SERVICE INFORMATION NO. SI 42-051

Thielert TAE Service Bulletin TM TAE 125-1004 P1
ATA-Code: 72-00

Service Bulletin No. / TM TAE 125-1004 P1, Initial Issue / September 14, 2007
Date:

Betrifft: Entfernen des kleinen O-Rings des Ölfiltermoduls
Subject: *Removing the small O-Ring of the Oil Filter Module*

Bild 1 / Fig. 1

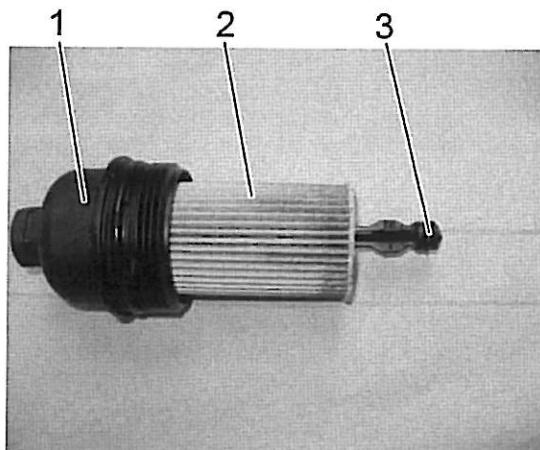
1. *Check the small o-ring for damages after remove of the oil filter. See Fig. 1.*
2. *If the small o-ring is damaged, make sure that no parts of the small o-ring are missing.*

■ **CAUTION:** *If any parts of the small o-ring are missing contact Thielert Aircraft Engines GmbH!*

3. *Remove the small o-ring without replacing it.*
4. *Finish the exchange of the oil and oil filter according to the current Operation & Maintenance Manual OM-02-02.*

Bild 2 / Fig. 2

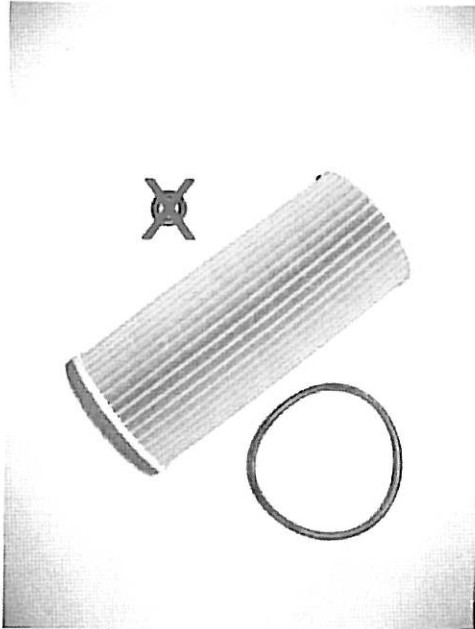
Do not use any longer the small O-Ring with the 100h Service Kit. See Fig. 2.
